GENUINE MOTOR PARTS AND MOTOR ACCESSORIES BULLETIN

PAB1146

PAB1146: 68193-95 BULB WEDGE, FENDER TIP LAMP

Figure 1. Incorrect vs Correct Bulb

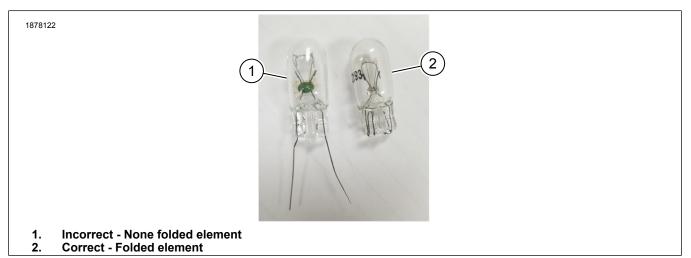
Harley-Davidson has found an issue with the wire terminals on the light bulb (Part No. 68193-95) not being folded and molded back into the housing. The bulb style has been corrected by working with our supplier.

Shipments of the incorrect bulb (1) started in March 2022 and ended in August 2023 with the following packages dates March 25, 2022 and October 24, 2022. Inspect your inventory of this part and dispose of the defective stock. Submit a warranty claim for reimbursement. Refer to Credit Procedure.
